## **DEVELOPMENT APPLICATION ASSESSMENT REPORT**

Application Number:	DA2018/1234	
r.r		
Responsible Officer:	Maxwell Duncan	
Land to be developed (Address):	Lot 2 DP 19067, 41 Lewis Street BALGOWLAH HEIGHTS NSW 2093	
Proposed Development:	Alterations and additions to an existing dwelling house	
Zoning:	Manly LEP2013 - Land zoned R2 Low Density Residential	
Development Permissible:	Yes	
Existing Use Rights:	No	
Consent Authority:	Northern Beaches Council	
Land and Environment Court Action:	: No	
Owner:	Tanya Middleton	
Applicant:	Gregory John Middleton Tanya Middleton	
Application lodged:	20/07/2018	
Integrated Development:	No	
Designated Development:	No	
State Reporting Category:	Residential - Alterations and additions	
Notified:	15/11/2018 to 03/12/2018	
Advertised:	Not Advertised	
Submissions Received:	3	
Recommendation:	Approval	
Estimated Cost of Works:	\$ 410,000.00

Image 1- Survey confirmation of height poles (submitted to Council 22 February 2019).

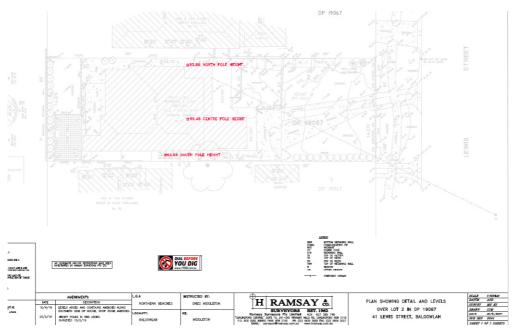
Submissions have been received from two (2) neighbouring properties at No. 39 Lewis Street, Balgowlah Heights and No. 1 Gertrude Street, Balgowlah Height raising view loss as an issue. To assist Council in its assessment of the application, Council made a request to the applicant on 20 December 2018 to erect height poles. The applicant subsequently erected height poles with certification of the height and location of the poles provided by a registered surveyor on 22 February 2019. The location of the height poles is shown below:
